PROBATION CONTROL STAMP			
DCG			
G10			
DO NOT SCALE DRAWING			
FIRST SHEET OF MULTI-SHEET DRAWINGS SHALL ALWAYS HAVE THE SAME REVISION LEVEL.			
DRAWN BY: S. ESP		CHECKED BY: ALAN R. GUNIA	
DATE: 29 JUL 08		DATE: 29 JUL 08	
APPROVALS:		APPROVED BY: J. H. H. H.	
DATE: 29 JUL 08		DATE: 29 JUL 08	
SCALE: 1:1		SCALE: 1:1	
SHEET NO. 1 OF 1		SHEET NO. 1 OF 1	
PROJECT: HALL A - TRANSVERSITY - E06-010		PROJECT: HALL A - TRANSVERSITY - E06-010	
SUBJECT: PU COIL - COLIM - DUMP ASSY		SUBJECT: PU COIL - COLIM - DUMP ASSY	
MOUNTING PL FOR PU-COIL-IM-DUMP		MOUNTING PL FOR PU-COIL-IM-DUMP	
REV: B		REV: B

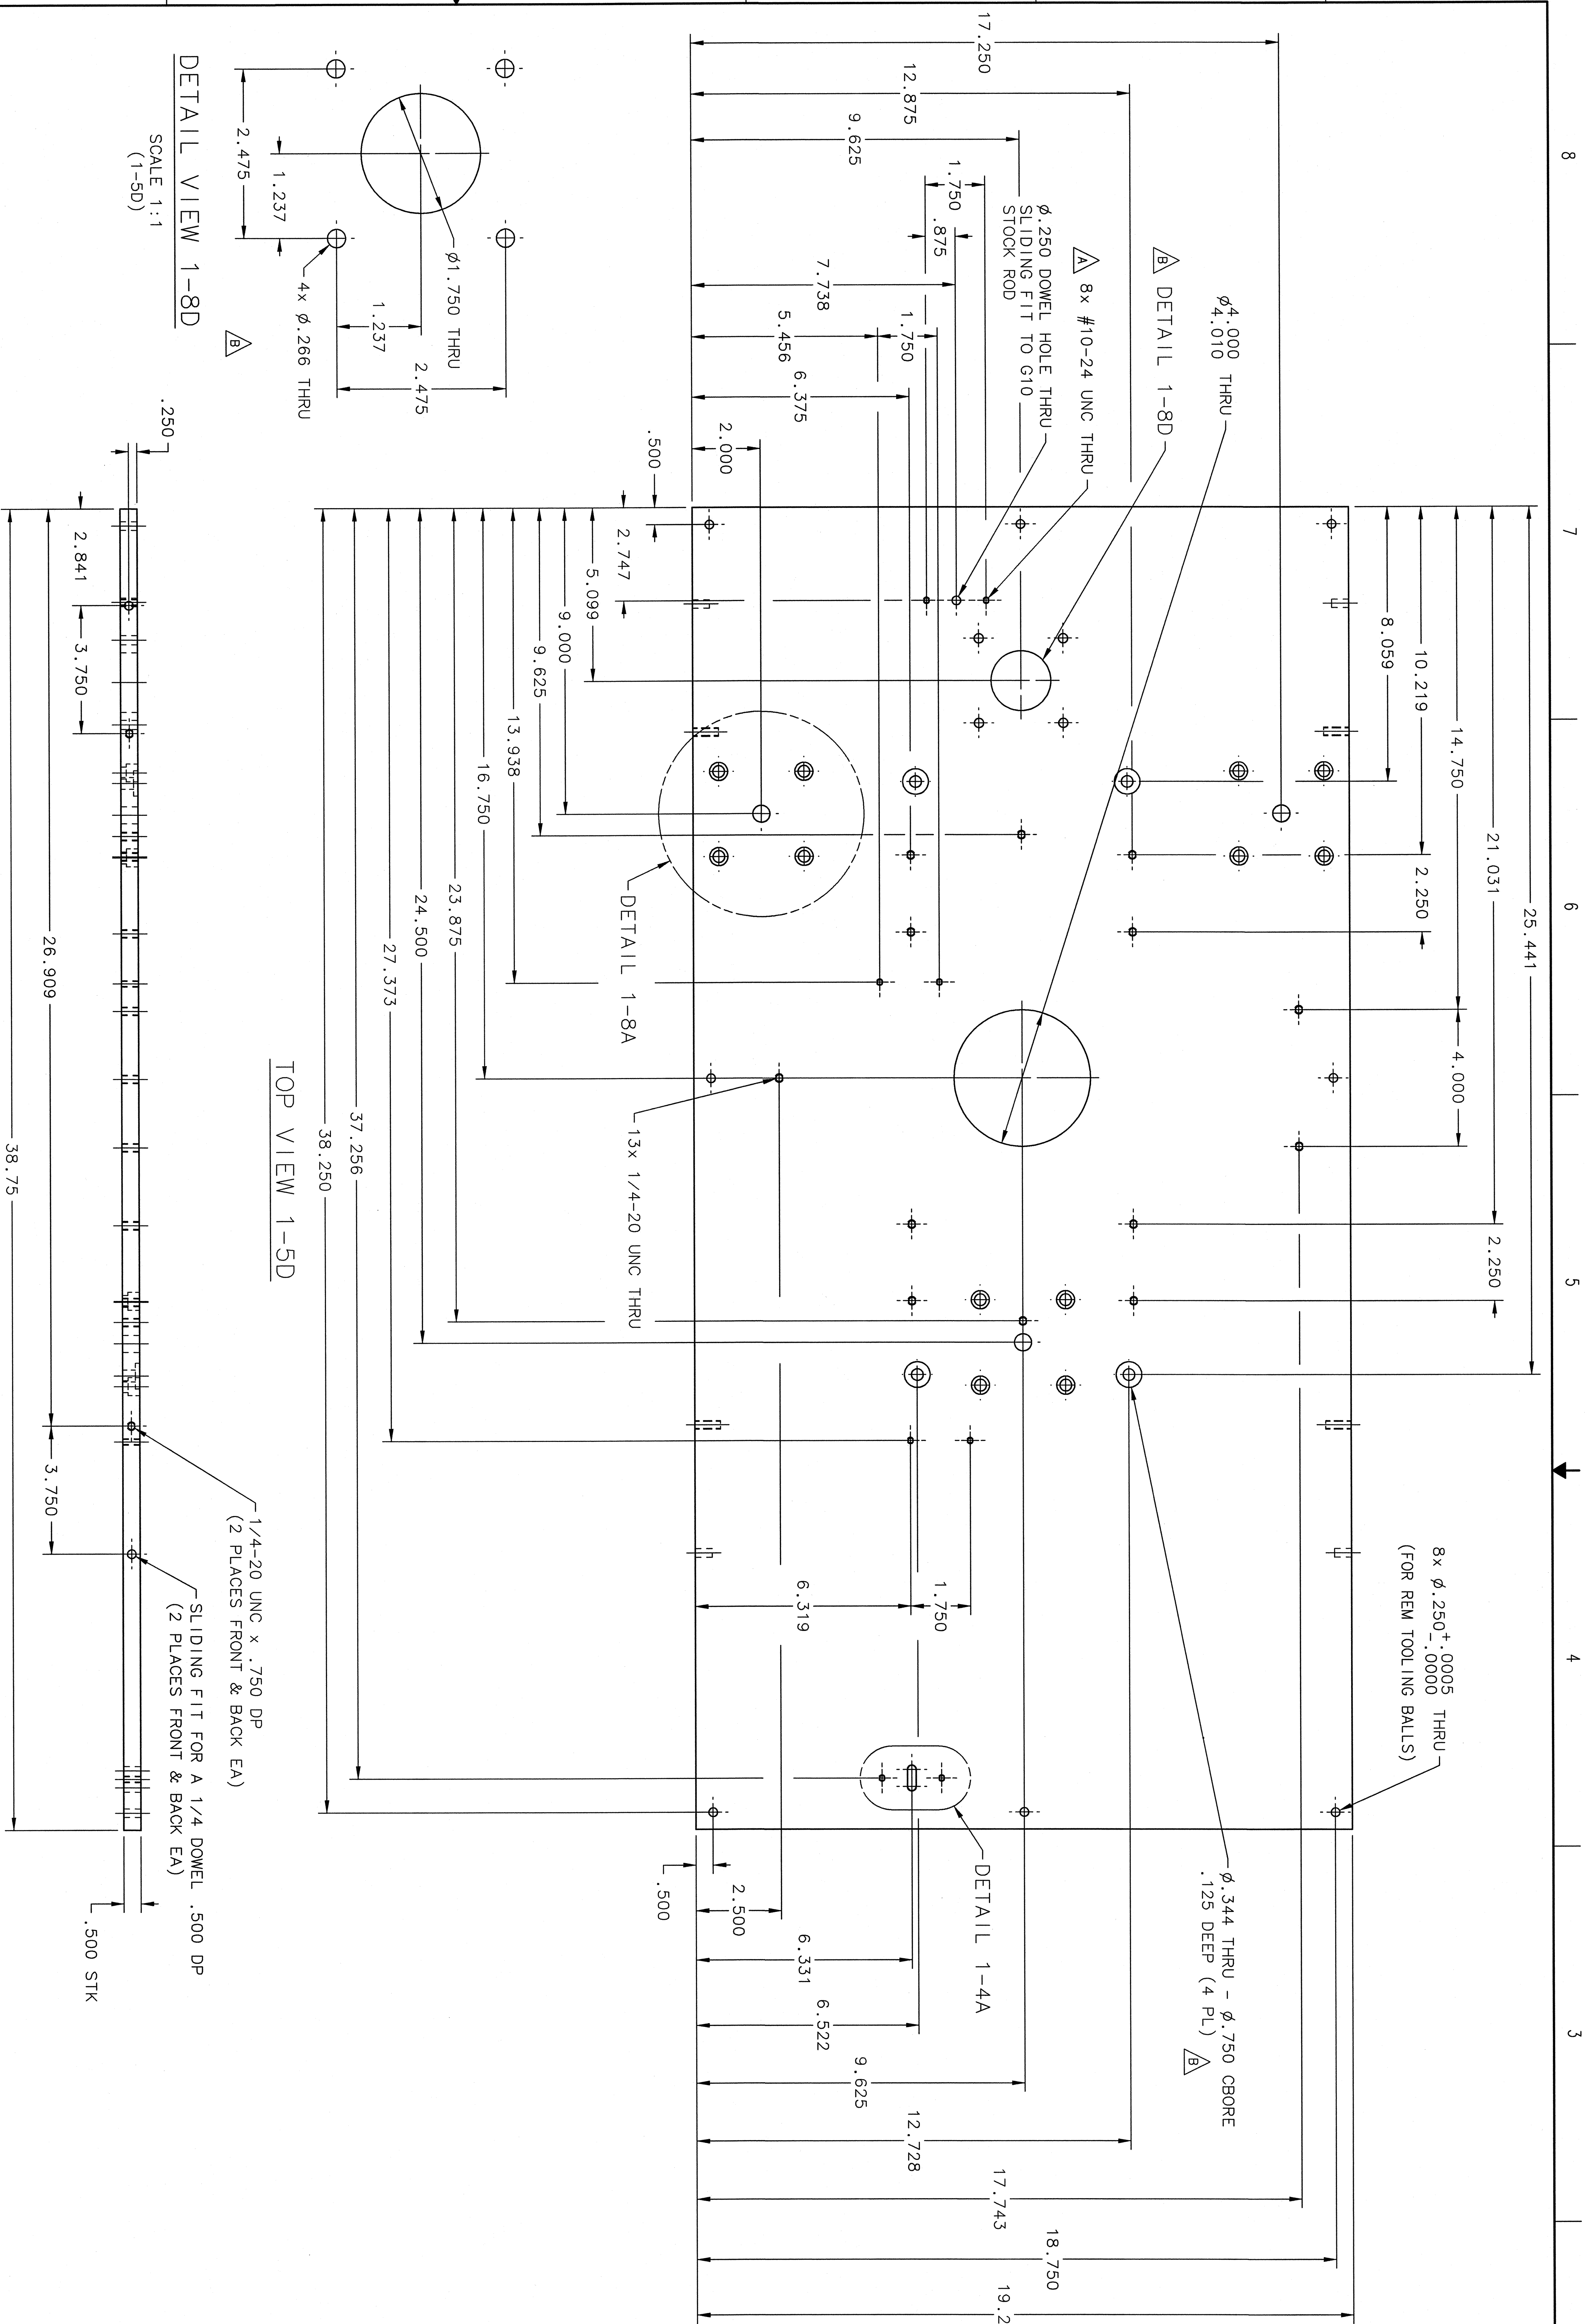
REVISION HISTORY			
ZONE	REV	DESCRIPTION	DATE
1-86	A	ADDED 8x #10-24 UNC THRU HOLES AND A .250 DIA DOWEL HOLE.	13 AUG 08
1-44	A	CREATED A NEW DETAIL VIEW 1-4A THAT DESCRIBES THE SLOT ADDED.	14 AUG 08
1-86	B	ADDED FEATURES (5 HOLES) FOR THE BRO VIEW CAMERA & LOCATING DIMS 9.625 & 5.099	26 AUG 08
1-80	5.099	CREATED DETAIL VIEW 1-8D.	
1-36	1-36	ADDED A .750 DIA GROOVE x .125 DP TO EXIST .344 THRU HOLES - 4 PLACES	10/26/00
			0029
